Access Compliance Report Public Rights-of-Way (Curb Ramps)

Main Street: FOSTER_RD Cross Street: BOSTONIAN_DR Location: SW

ADA ID: RPRK211220131814 Ramp Type: Type 1 - Perpendicular Diagonal Initial Pass/Fail: Pass Overall Compliance: No Severity Score: 0

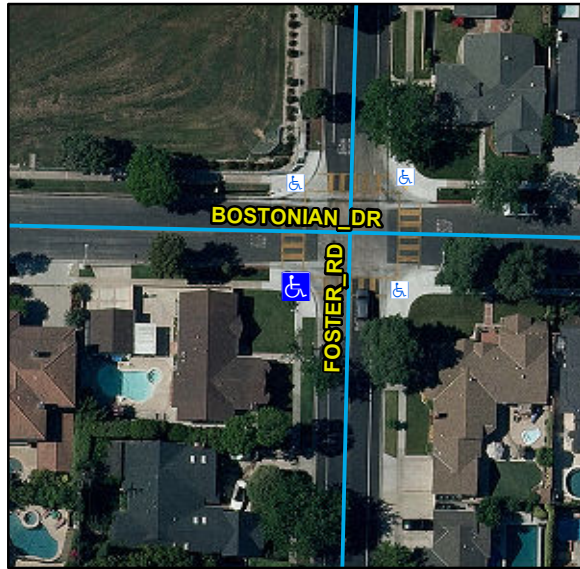
Compliance	Description	Data	Compliance	Description	Data
N/A	Ramp Length (in)	72	N/A	Flare Type LT	
Yes	Ramp Width (in)	48			Sloped
Yes	Ramp Run Slope (%)	6.9	N/A	Flare Slope LT (%)	5.2
Yes	Ramp Cross Slope (%)	0.2	N/A	Flare Traversable LT	No
N/A	Landing Present	Yes	N/A	Flare Type RT	
N/A	Landing Length (in)	48			Sloped
Yes	Landing Width (in)	48	N/A	Flare Slope RT (%)	6.2
Yes	Landing Run Slope (%)	0.9	N/A	Flare Traversable RT	No
Yes	Landing Cross Slope (%)	0.5	Yes	DWS Provided	Yes
N/A	Landing Movement Obstructed?	Yes	Yes	DWS Contrast	Yes
	Landing Movement Type	Curb	Yes	DWS Length (in)	36
N/A	Landing Shared	No	Yes	DWS Full Width	Yes
Yes	Clear Space	Yes	Yes	DWS Offset Left (in)	0
Yes	Clear Space To Crosswalk (in)	48	Yes	DWS Offset Right (in)	N/A
N/A	Marked Crosswalk 1	Yes	N/A	Marked Crosswalk 2	Yes
	Crossing 1 Direction	E		Crossing 2 Direction	N
	Marked Crosswalk 1 Width (in)	144		Marked Crosswalk 2 Width (in)	144

Remove & Replace Landing.
